April 20, 2012

**Re: A.12-01-012 – Santa Cruz 115 kV Reinforcement Project
PG&E’s Response to First Set of Data Requests**

Attachment D: Additional Temporary Construction Areas Map

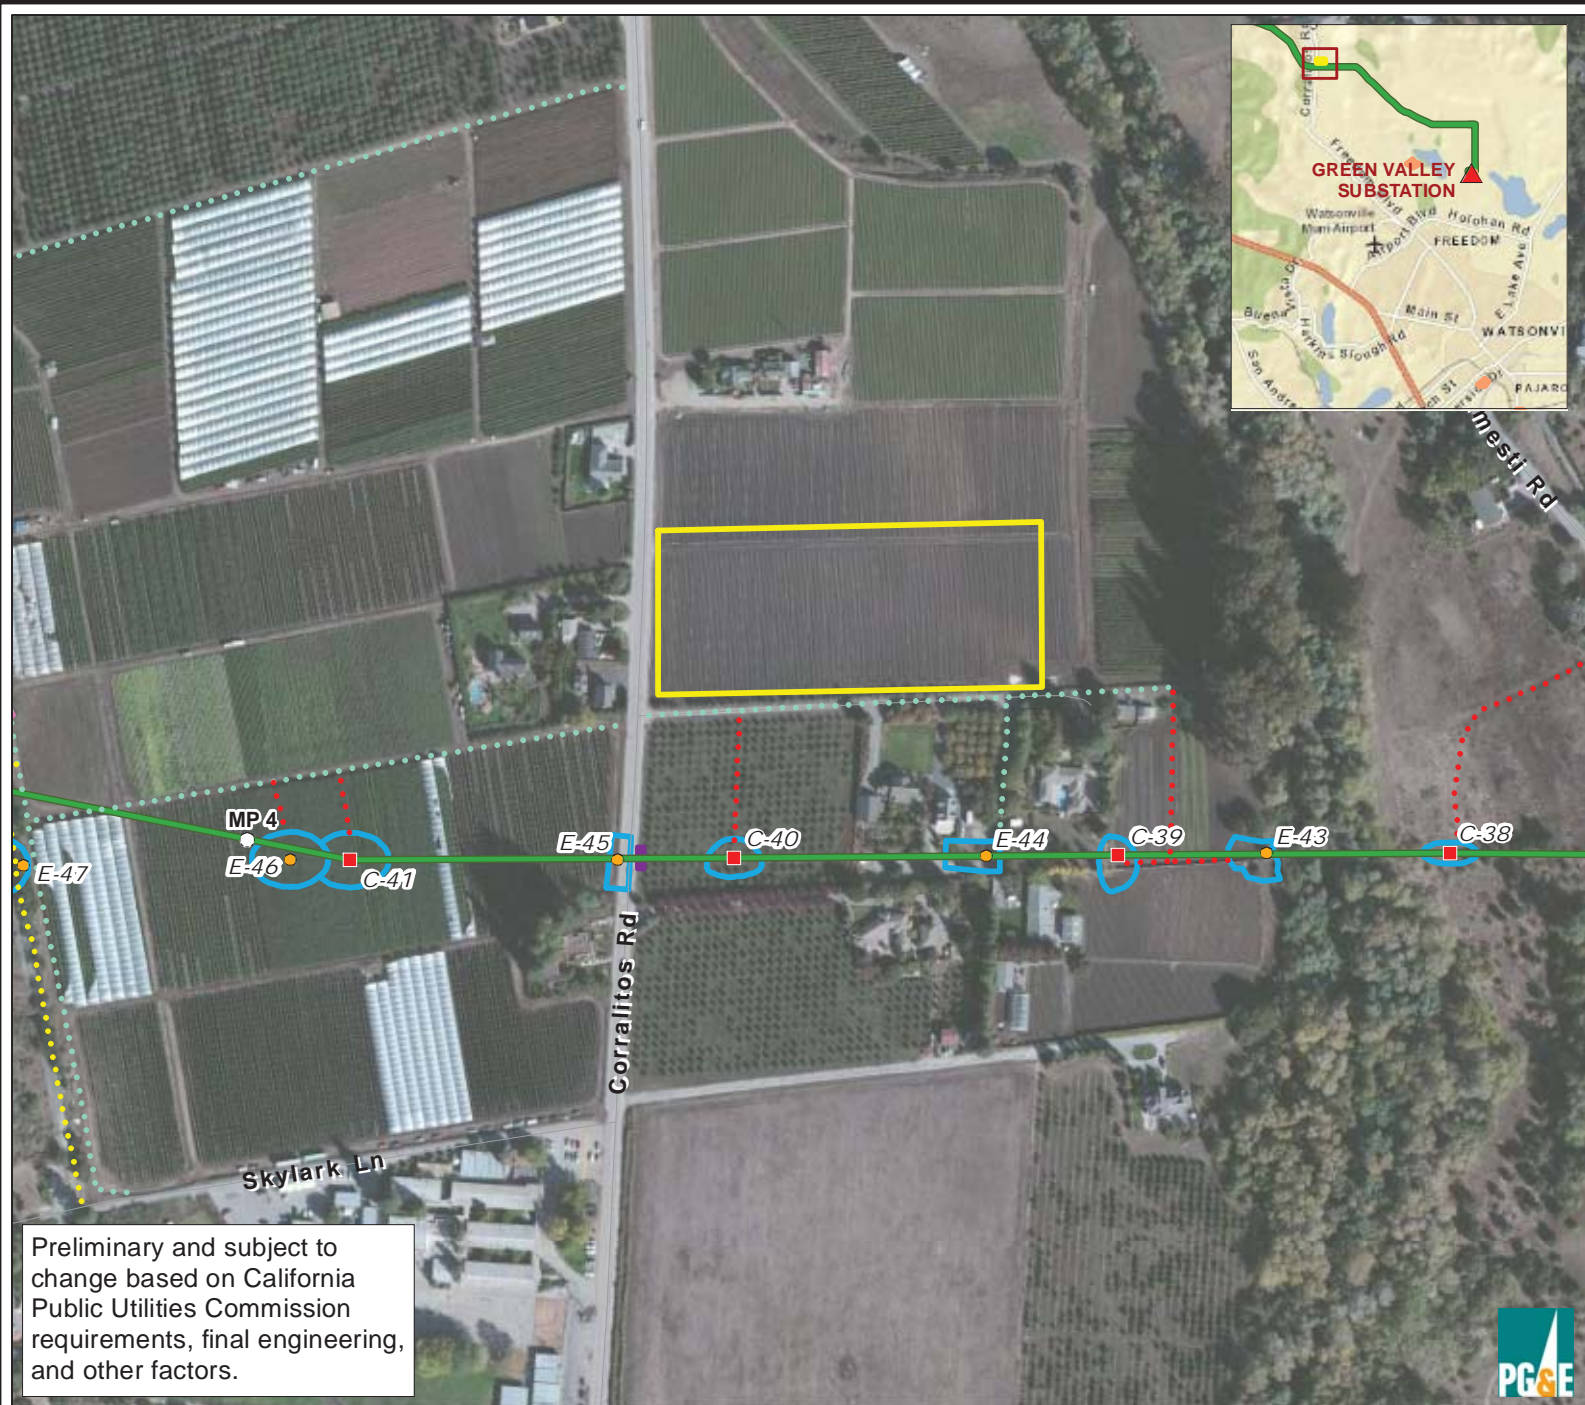
Section 2.7.3 and 2.7.4, pages 2-26 through 2-27. Will two staging areas and one storage yard be enough to serve the project during construction? New staging areas and storage yards in the past have only been added by variance request during construction. Nesting bird issues can render staging areas unusable. Consider identifying additional staging area options and storage yards in the PEA so that they can be fully assessed in the impact assessment, reducing the need for variances during construction.

As described previously in response to CPUC Data Request Question #9, two additional contractor storage yards and one additional staging area/landing zone will be added to the project. The contractor storage yard at Amesti Road and the staging area/landing zone will be completely mowed of vegetation prior to use. A portion of the contractor storage yard at Sakata Road will also be mowed prior to construction. These areas of vegetation clearing total approximately 11 acres. With these additional temporary construction areas included, a total of approximately 40 acres of vegetation clearing will be required.

CROSSING STRUCTURE TYPICAL DRAWING

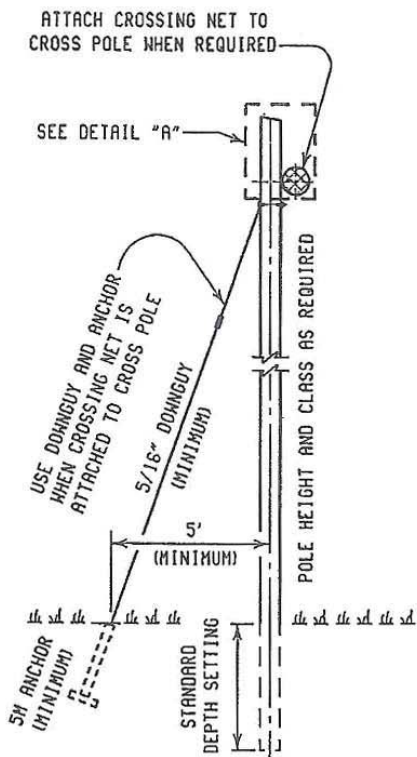
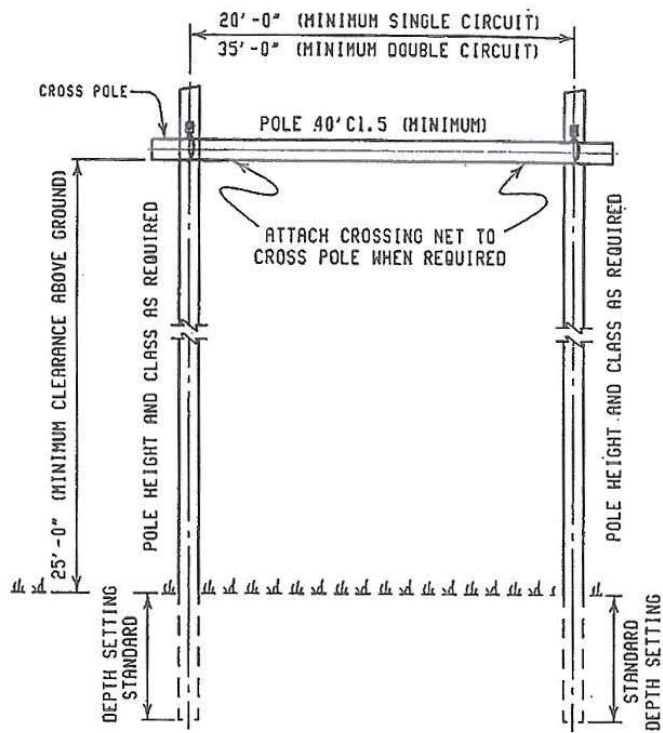
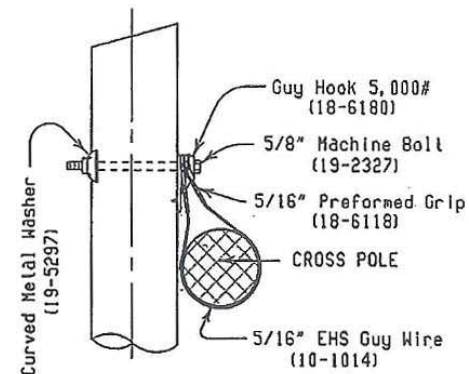
Section 2.7.8, page 2-31. Please provide a graphic showing a crossing structure.

Attachment F: Crossing Structure Typical Drawing depicts a typical crossing structure.
